Sundry Print Report

Well Name: GALLEGOS CANYON UNIT

Notice of Intent - Plug and Abandonment

Operator: Simcoe LLC
Lease: NMSF078807A
Agreement: NMNM78391A
Well(s): Gallegos Canyon Unit 275, API # 30-045-22251
Location: NWNW Sec 13 T28N R13W (San Juan County, NM)
Sundry Notice ID#: 2837339

GCU 275
PC
API # 30-045-22251

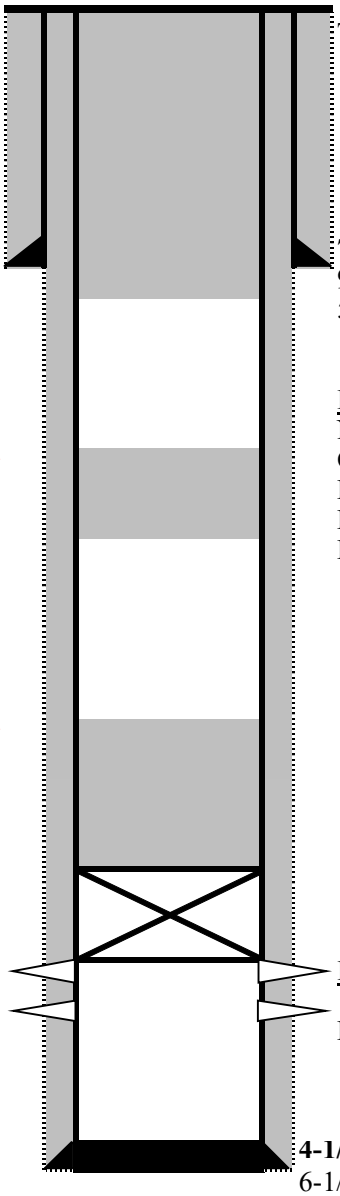
a. Adjust Plug 1 (Picture Cliffs/Fruitland) to cover the BLM geologist's Fruitland formation top pick @ 910'. Plug should cover 860' - 1321', estimated minimum 33 sx not including excess.

b. Adjust Plug 2 (Kirtland/Ojo) to cove the BLM geologist's Kirtland and Ojo Alamo formation top picks @ 545' and 410', respectively. Plug should cover at a minimum 360' – 595', estimated minimum 19 sx not including excess.

Remarks: Please adjust plugs to account for BLM-picked formation tops.
